HAMMAM AL ALIL DIVISION TRAINING
CENTER
MOSUL, IRAQ

SIGIR PA-09-174
JANUARY 7, 2010

Summary of Report: PA-09-174

SUBJECT: Report on the Hammam Al Alil Division Training Center, Mosul, Iraq
(SIGIR Report Number PA-09-174)

Figure 4. Multi-purpose small arms range layout (Courtesy of USACE)

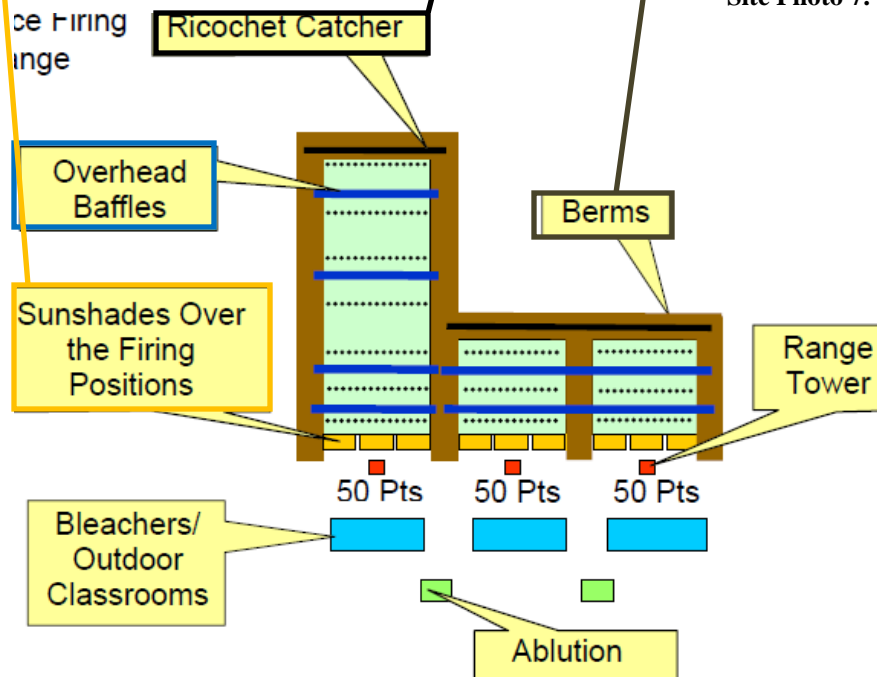
The SOW required the construction and installation of overhead baffles between the firing positions and the terminal end of the range (Figure 4). Overhead baffles were designed to contain all bullets fired from a prone or kneeling position. Also, the overhead baffles were designed to contain shots that would otherwise travel over the berm.

Due to the descoping of the overhead baffles, the multi-purpose small arms range was no longer considered a fully contained range. The GRN Mosul Area Office documentation did not address the status change of the range from a fully contained range⁶ to a non-contained range⁷. In addition, the documentation did not address the safety concerns of removing the overhead baffles or the impact on public safety.

In response to a draft of this report, the Gulf Region District of the U.S. Army Corps of Engineers (USACE) stated: “On 1 December 2009, the GRN Mosul Resident Office provided SIGIR documentation showing the chronology of events concerning the construction status of the range baffles and the customer’s decision to remove them. In addition, that the contractor’s program manager stated that the Iraqis, the end users, didn’t see a need for the baffles. The 30-foot berm at the terminating end of the range serves as the primary backstop. Further, the facility is located 24 kilometers south of Mosul in an isolated and sparsely populated area so the potential for collateral damage or injury is minimal.”

Figure 5. Multi-purpose small arms range electrical plan (Courtesy of USACE)

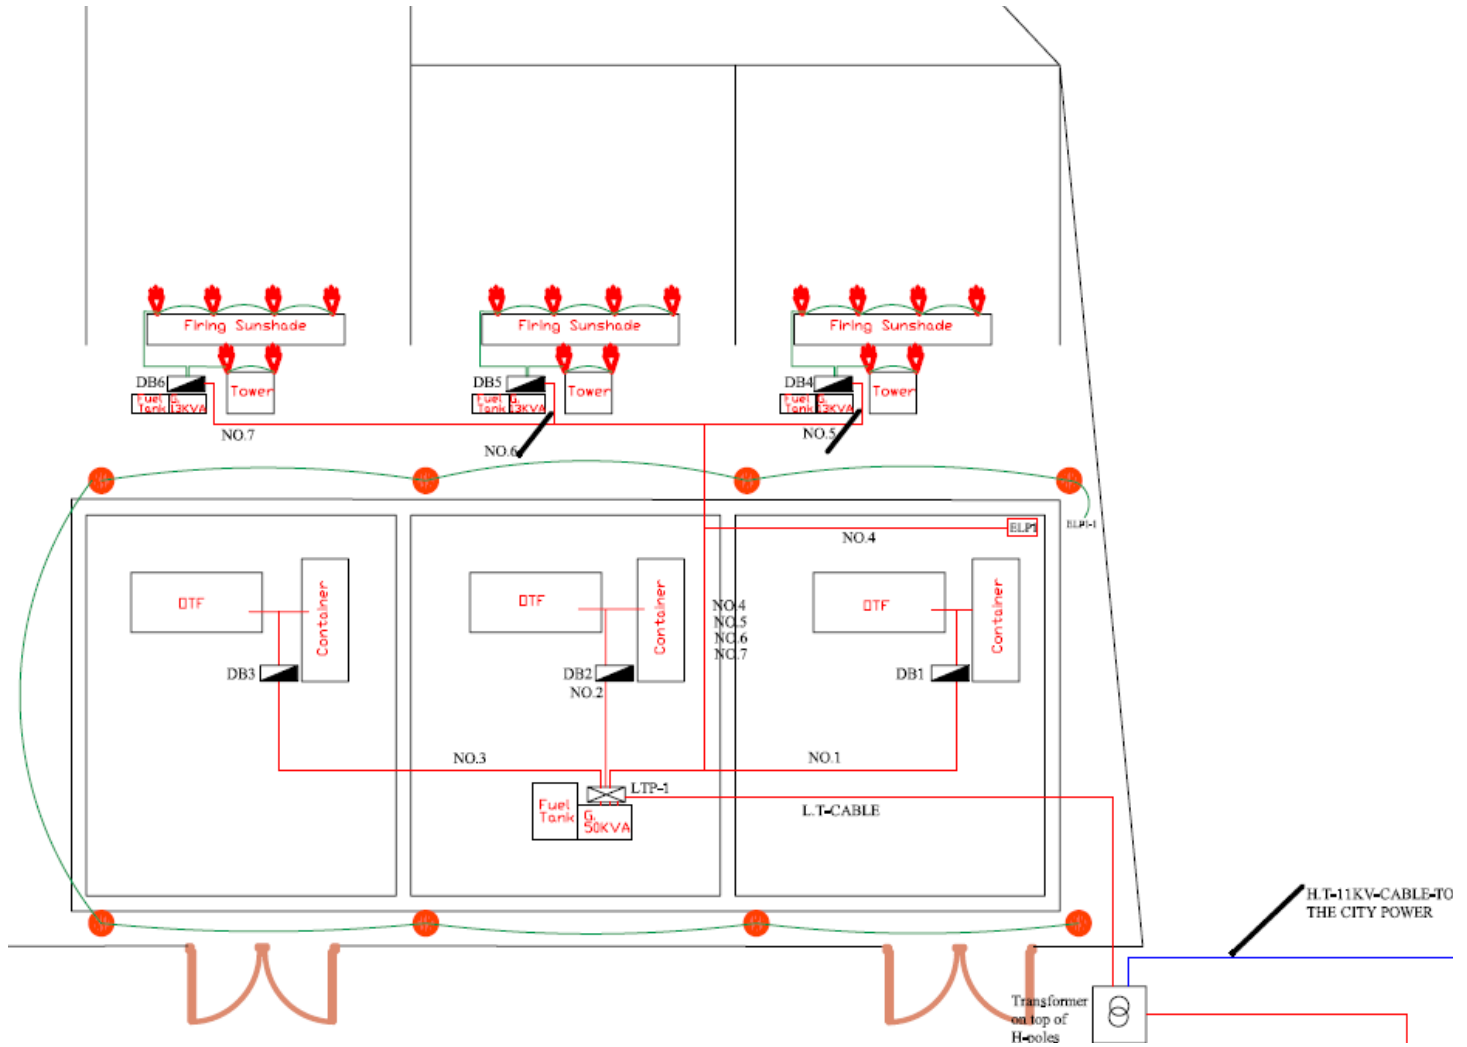
The electrical system for the multi-purpose small arms range consisted of a small generator, exterior fuel tank, distribution system, and exterior lighting (Figure 5). The SOW did not include requirements on the actual size or capacity of the generator. Also, the contractor did not provide calculations to determine if the generator provided meets the current and future requirements for power for the multi-purpose small arms range and MOUT facility.

The generator was connected to the fuel tank with galvanized steel piping. SIGIR noted that there was evidence of a fuel leak at one of the joints in the fuel line (Site Photo 12). The GRN Mosul Area Office representative stated that the leak was previously discovered and repaired and that the fuel noted during the site assessment was from an earlier leak. As the Gulf Region District of USACE stated in response to a draft of this report: “Given the frequent sand and dust storms in Iraq, dirt would have re-accumulated had the pipes and foundation been pressure washed or replaced when the leak was repaired.”
